## **14.1.9 Loss of External Electrical Load**

### **Accident Description**

FIGURE 14.2.6-11

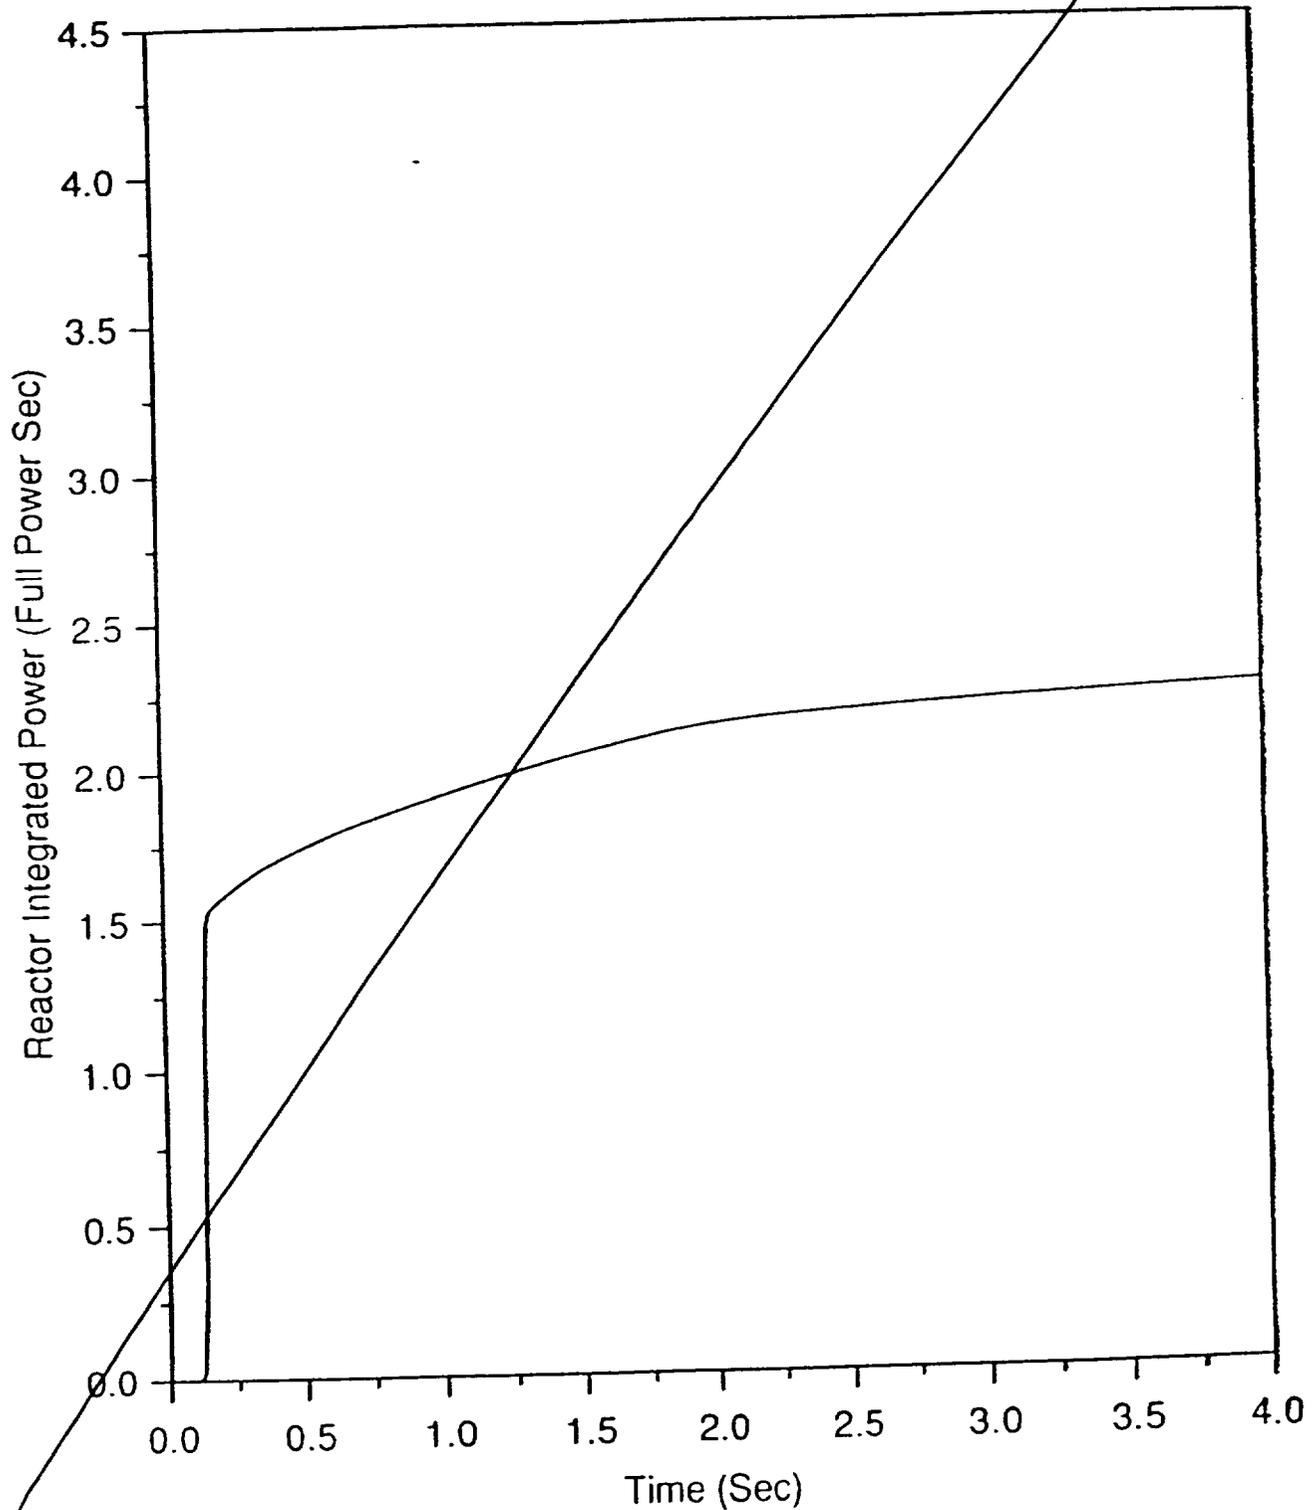
delete

FIGURE 14.2.6-12

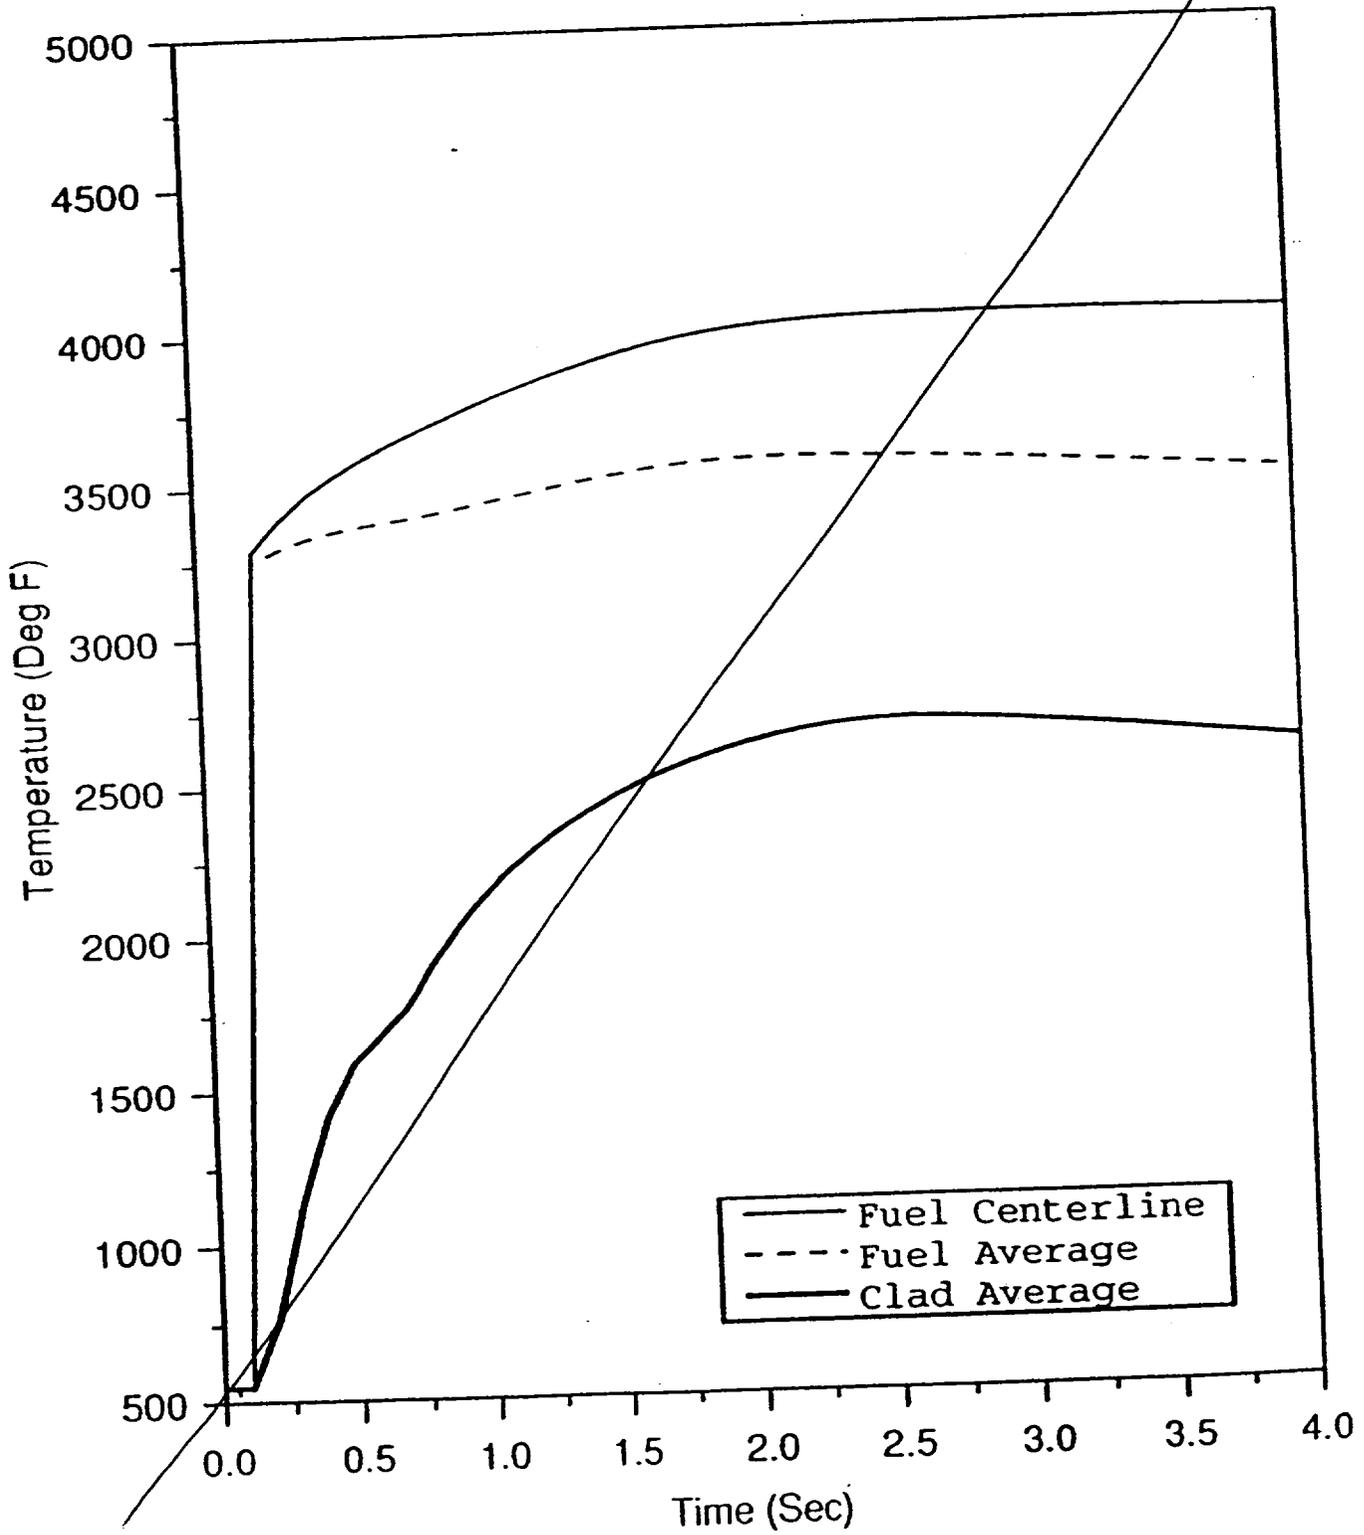
replace
